SERVICE BULLETIN

Reg. No.: 450 / 97

RM4260 / RM4270 / RM4290 / RM4360 / RM4400 / RM5270 / RM5405 and ignition-variants

INSUFFICIENT COOLING PERFORMANCE INSIDE THE FREEZER COMPARTMENT

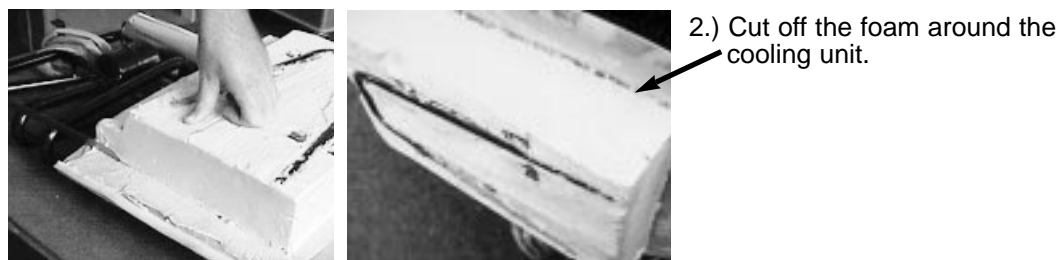
During production of some caravan refrigerators with wide freezer compartment, the evaporator tube has been foamed in (FIG.1). Consequently, there is no contact between the evaporator tube and the freezer compartment, causing low cooling performance.

- 1.) Remove the cooling unit.
- 2.) Check if the tube is over foamed (see FIG.1).
- 3.) If this is the case, change the cooling unit.
- 4.) Rework the removed cooling unit in the service-station and use it for the next service.

- 1.) Remove the foam entirely until the evaporator tube is visible. The evaporator tube should protrude 3mm.

3.) Remove all nuts (plastic) from the fixation clamps.

4.) Fit in the new metal nuts (spare part number 210 6626-00/1).

5.) Clean the cooling unit thoroughly.

6.) Before reinstalling the cooling unit, it is necessary to put thermal mastic onto the evaporator tube.
